CITY OF WICHITA

Wichita-Sedgwick County Metropolitan Area Planning Department

Re: BZA2019-00020: Administrative Adjustment to reduce the front setback by 20% on property zoned SF-5 Single-Family Residential.

SITE PLAN
APPROVED 4/26/19 RLMorga

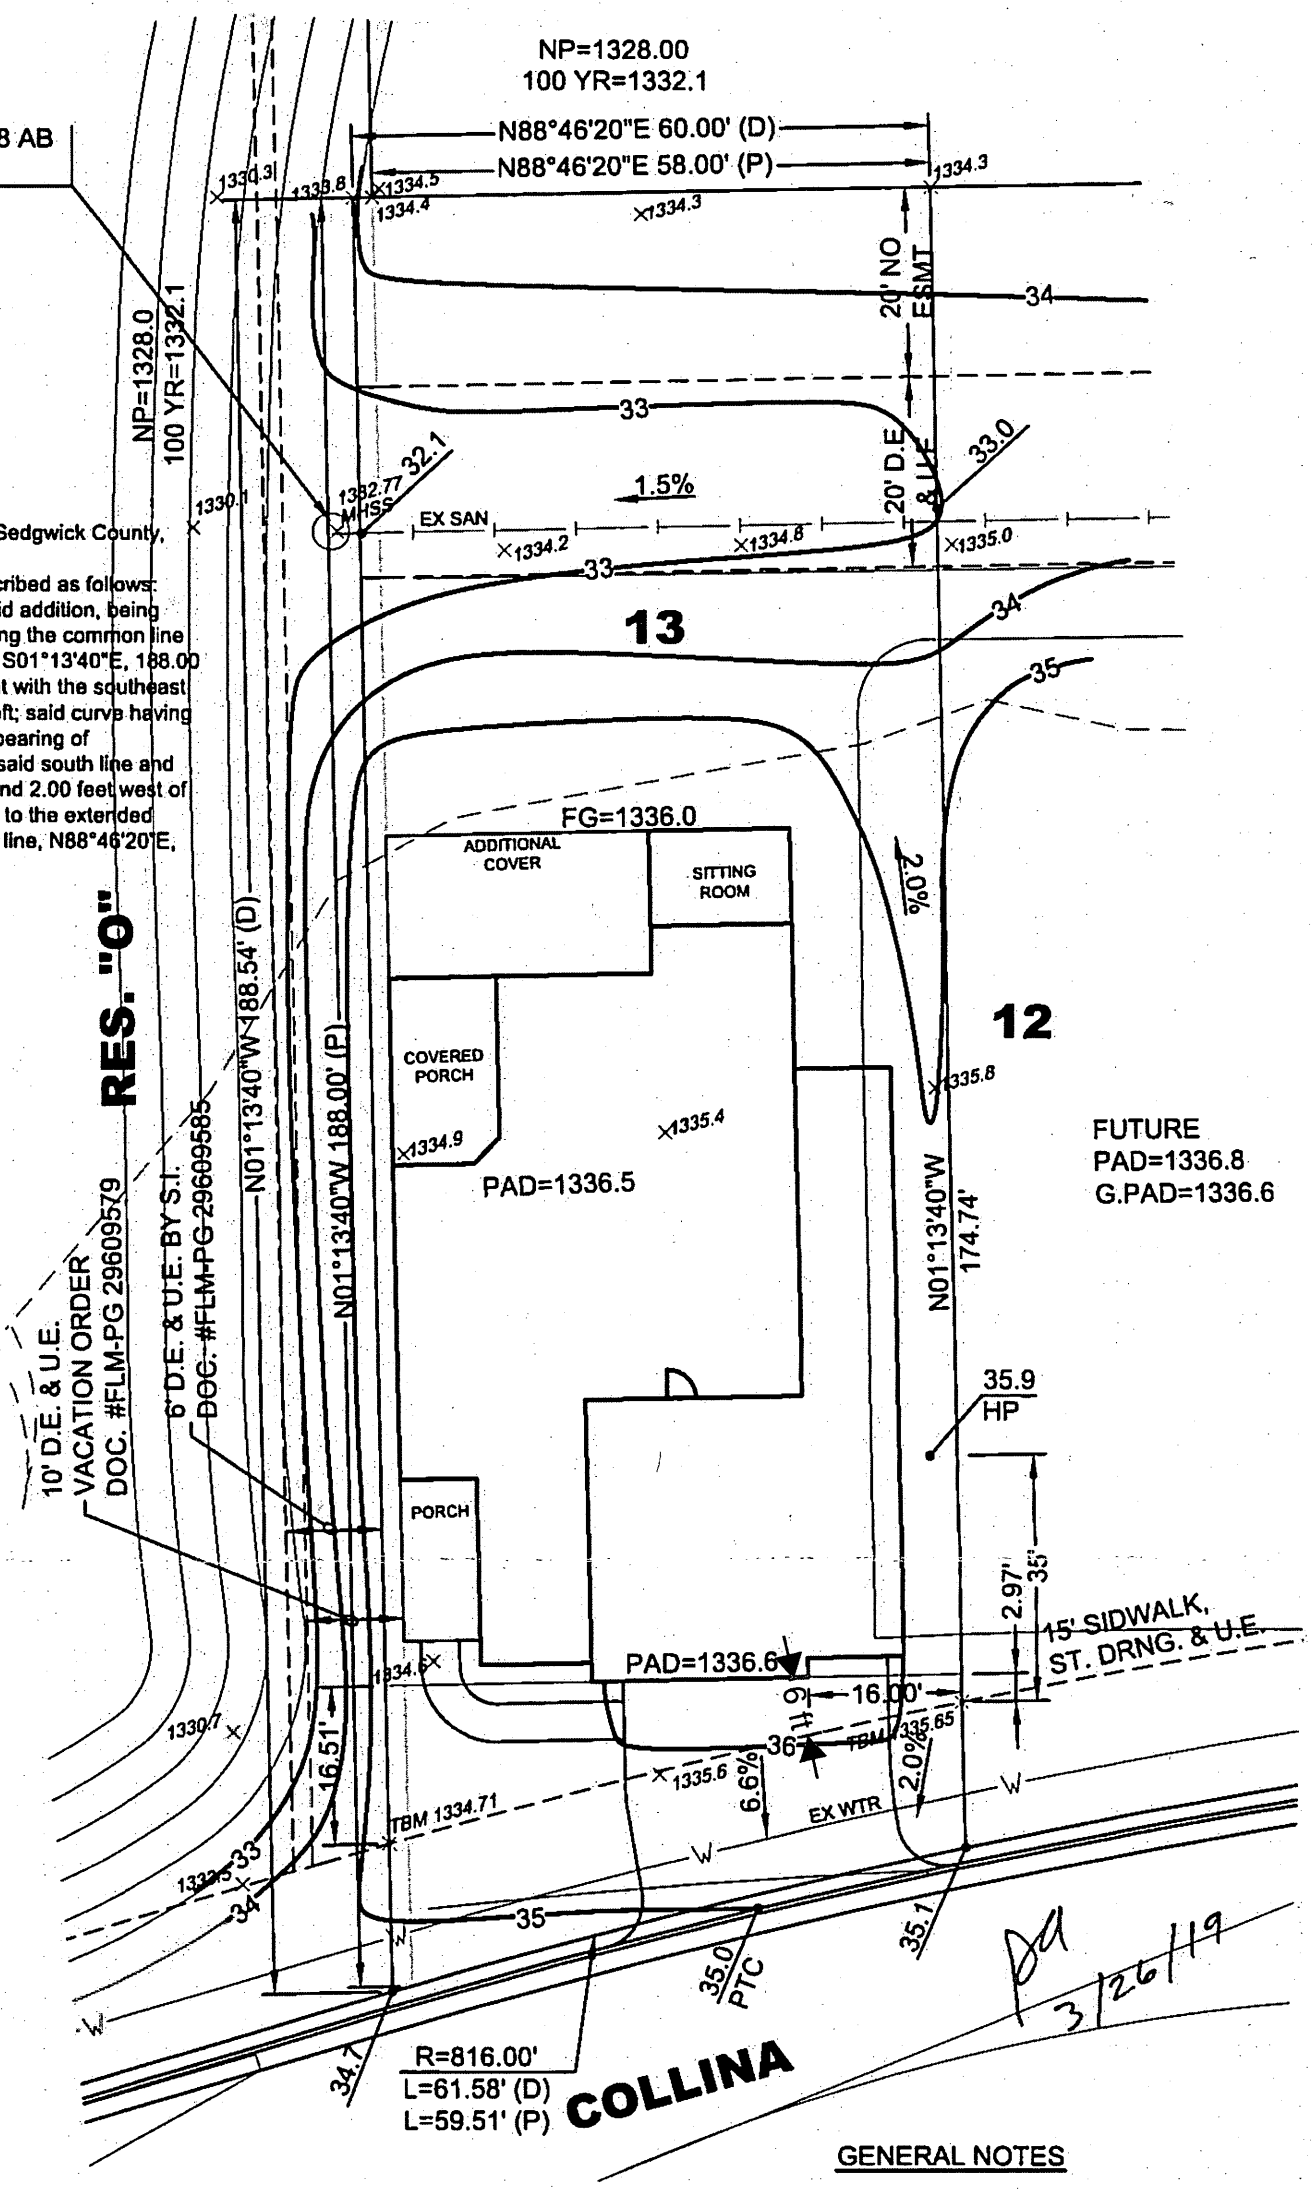
We have reviewed your request for a Zoning Adjustment to reduce the front setback on the aforementioned property. From reviewing the application, we understand that you desire to reduce the front setback from 25-feet to 20-feet so that you may build a new residence.

1) Impact on safety and convenience of vehicular and pedestrian circulation: Construction of a new residence should have no impact on the safety and convenience of vehicular and pedestrian circulation in the vicinity as right-of-way and driveways are not affected.

2) Impact on existing uses in surrounding areas: There will be no impact on the existing uses in surrounding areas as a result of the new construction; street visibility will be unchanged for neighboring properties.

3) Compatibility with existing or permitted uses on abutting sites: Abutting sites are zoned SF-5 Single-Family which allows residential development and the front yard setback reduction will not have a negative impact on existing or permitted uses.

4) Effect on public health, safety or welfare: There will be no encroachment into public utility easements or right-of-way. There will be no negative impact on the public health, safety or welfare, nor will properties or improvements in the vicinity be materially injured.

Our signatures below indicate that a Zoning Adjustment to reduce the front setback for the aforementioned property to 20-feet is hereby **GRANTED**, subject to the following conditions:

1) The site shall be developed in general conformance with the approved site plan.

2) The applicant shall obtain a building permit and complete construction within one year of the Administrative Adjustment approval. The site shall conform to all codes including but not limited to building, health and fire.

3) The setback reduction shall apply only to the front setback as illustrated on the approved site plan. All other structures or additions on the subject property shall conform to the setbacks permitted by the Unified Zoning Code unless a separate Zoning Adjustment or Variance is granted.
